Responses by Chris McGranahan
LSC Transportation Consultants, Inc.
February 18, 2022

NOTE: This project is now referred to as Phase 6 Filing 6

Re: Horizon Uptown Phase 5
Aurora, CO
LSC #210520

Summary of Comments on HUF6 TIS Comments With LSC Response.pdf

Table 3
95th Percentile Queue Lengths and Auxiliary Turn Lanes ^{(1) (2) (3)}
Horizon Uptown Phase 5
Aurora, CO
LSC #210520; December, 2021

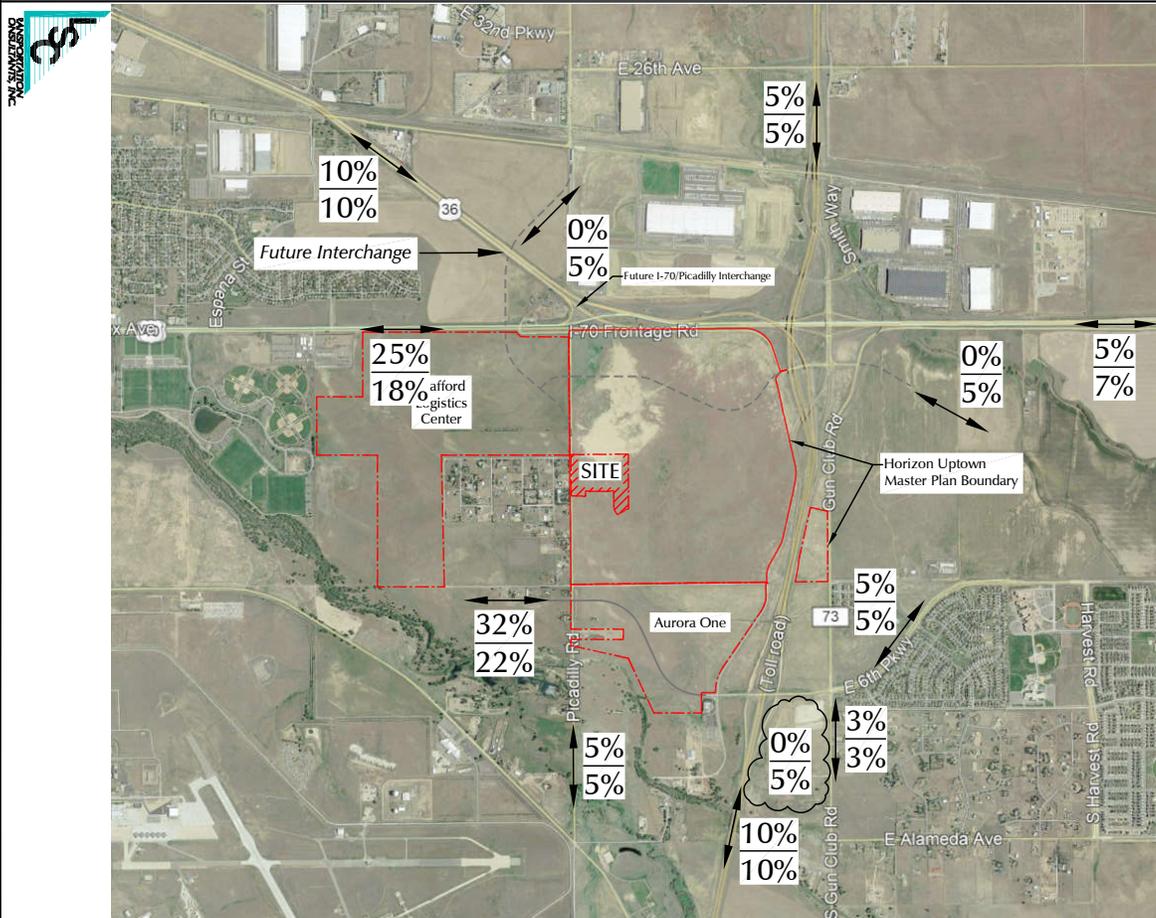
Provide queuing summary table for intersections 2 and 5 as well. 1

Provide queuing summary table for intersections 2 and 5 as well.

Author: kdferrin Subject: Sticky Note Date: 2/4/2022 10:16:10 AM
LSC Response: The table has been revised as requested
